Docket Number:	16-AFC-01
Project Title:	Stanton Energy Reliability Center
TN #:	217461
Document Title:	Stanton Energy Reliability Center's Data Request Response, Set 1 (A1 - A63)
Description:	N/A
Filer:	Patty Paul
Organization:	CH2M
Submitter Role:	Applicant Consultant
Submission Date:	5/5/2017 4:15:40 PM
Docketed Date:	5/5/2017

Subject: Stanton Energy Reliability Center (16-AFC-1) Data Request Response, Set 1 (A1-A63)

Responses to California Energy Commission Staff
Data Requests A1 through A63

Stanton Energy Reliability Center

Figure DRA18-1a
Generator Tie-Line and
Natural Gas Pipeline
Rights-of-Way
 Stanton Energy
 Reliability Center AFC
 Stanton, California

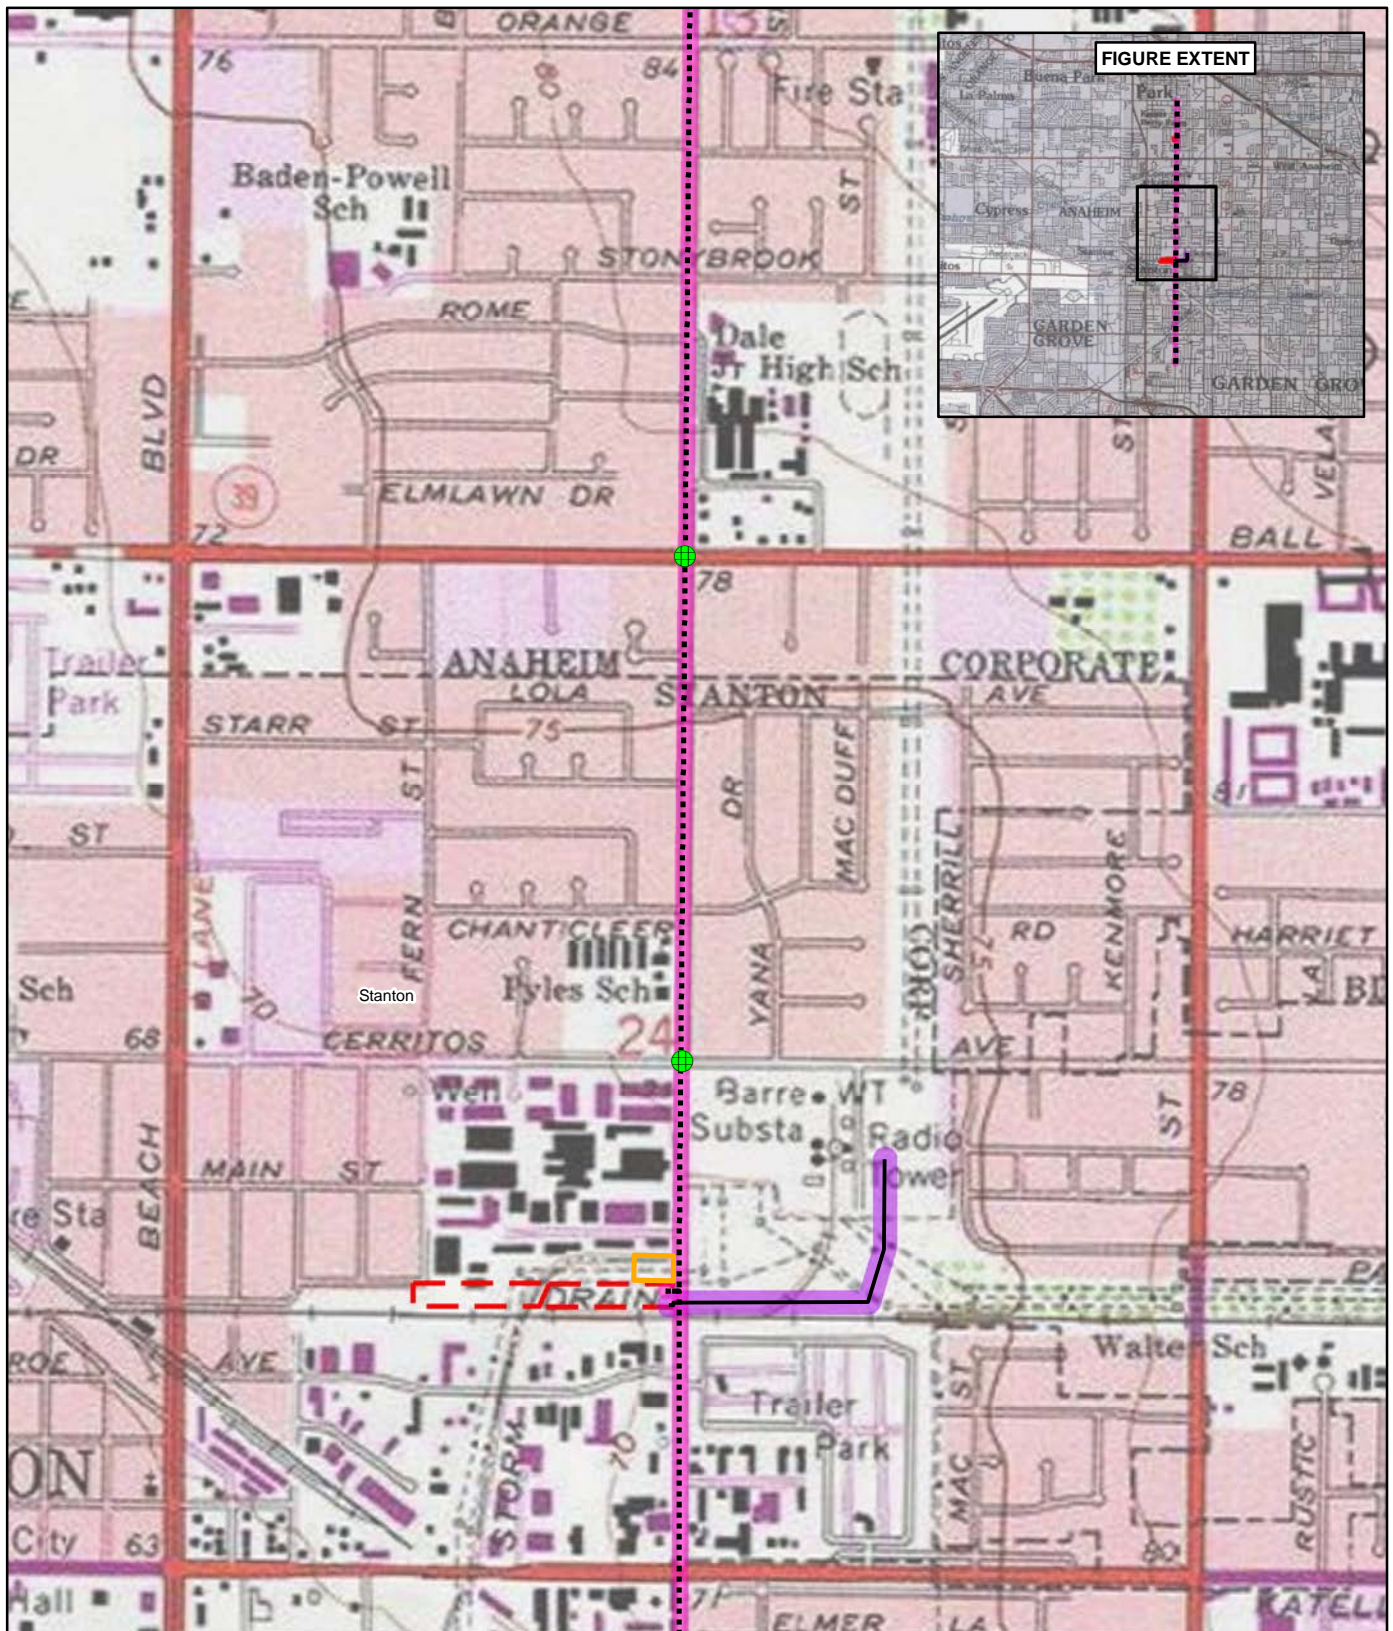
A18. *Please provide the right-of-way width required for the new generator tie-line (half and full right-of-way). Note any differences in right-of-way width requirements due to terrain or adjacent land uses or structures. Please map the right-of-way on aeries and a series of maps based on USGS 7.5-minute topographic maps enlarged to a scale of 1"=1,000 feet. Please provide the Geographic Information Systems shape files for the right-of-way. Please indicate areas of any new right-of-way versus existing right-of-way.*

Response: Attachment DRA18-1 is a series of maps showing the generator tie-line (and natural gas pipeline) route at the scale of 1"= 1,000 feet. Note, however, that the generator tie-line will be installed mostly within the SCE Barre Substation and, for that reason, will not require a right-of-way through private or public land, as SCE is the owner of the substation and will also be the owner and operator of the generator tie-line. Per SCE, the work area for the generator tie-line within the Barre Substation property will be approximately 50 feet wide.
